BEFORE AN EXPERT PANEL

FTAA-2512-1158

of an application by **Precinct Properties New Zealand Limited** for approvals under the FTAA for a listed project, The Downtown Carpark Redevelopment – Te Pūmanawa o Tāmaki (“**Application**”)

MEMORANDUM ON BEHALF OF MILLENIUM & COPTHORNE HOTELS NEW ZEALAND LIMITED

JOB TITLE: 196-200 Quay Street	
SKETCH TITLE: Structure Deformation Monitoring Station Drawings	
DATE: 15 June 2026	JOB No.: J000616
SCALE: NTS	SKETCH No.: SK17
DRAWN: D Michel	REV: A
VERIFIED:	APPROVED:
SOURCE OF BACKGROUND: REFER DRAWING TITLE BLOCK	
REASON FOR ISSUE: CONSENT

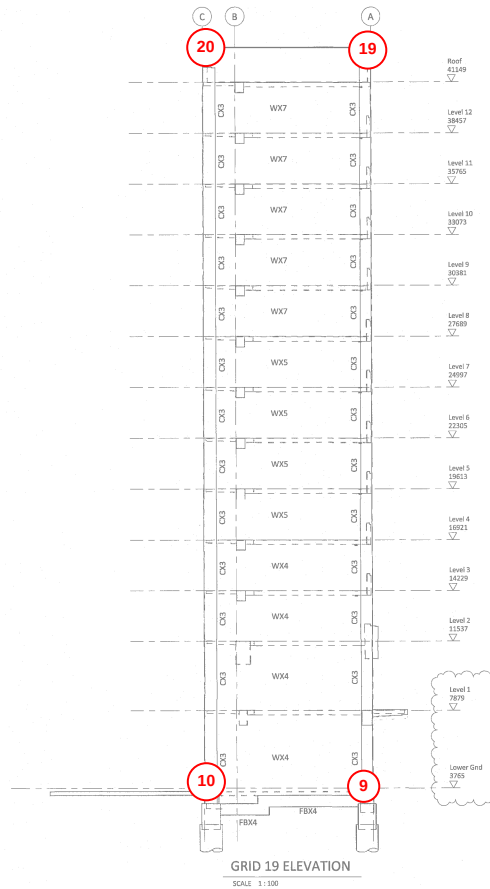
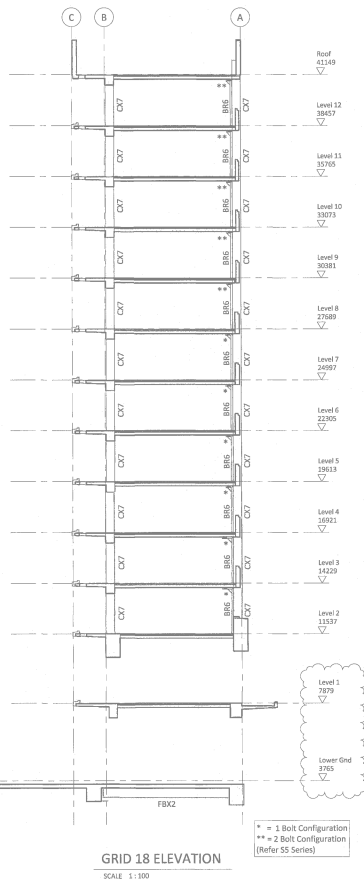
- b. Plan annotated by Structus showing the location of the 24 building / structure deformation monitoring stations recommended by that firm (see condition 166 / Schedule B on page 90 of the MCK Schedule).

Refer also Downtown Carpark Site Development - Conditions of Consent - Schedule B for definition of deformation stations required.
